RE: UC-6 Inlet As-Built, Dugout Canyon Mine, Canyon Fuel Company, LLC, C/007/039, Carbon County, Utah

Title: UC-6 Inlet As-Built

APPENDIX 7-9, ATTACHMENT D. UC-6 INLET AS-BUILT

UC-6 Inlet

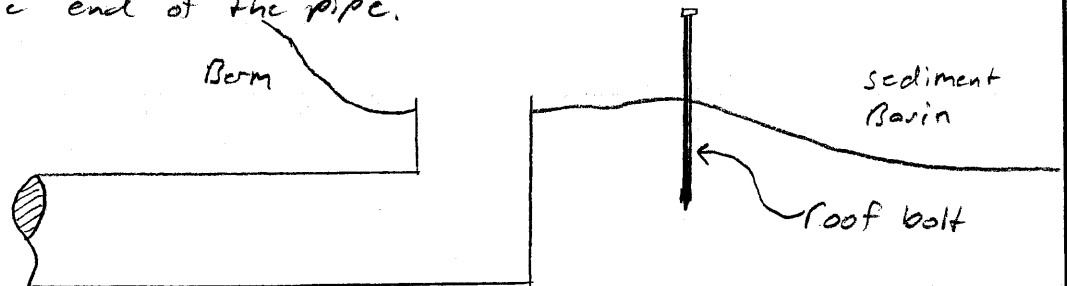
The inlet to UC-6 has been modified to prevent plugging by rocks and debris. To create room for a small sediment basin and roof bolts spaced approximately 3" apart to stop rocks and debris a vertical section of 18" pipe was put on the end of the pipe.

According to Appendix 7-9 the peak flow from the 10-year 24-hour storm is 1.02 cfs.

The headwater developed from this peak flow is determined from the following equation

$$Q = CLH^{3/2}$$

Q = flow (cfs)

C = Weir coefficient (Assume 3.0)

H = Headwater (ft)

L = Weir length (CMP circumference) = $\pi(1.5) = 4.71'$

$$H = (Q/CL)^{2/3}$$

$$H = [1.02 / (3.0 \times 4.71)]^{2/3} = 0.17 \text{ ft} = 2.1 \text{ inches}$$

To provide at least 1 foot of freeboard the berm around the inlet should be at least 14.1 inches high or 15"
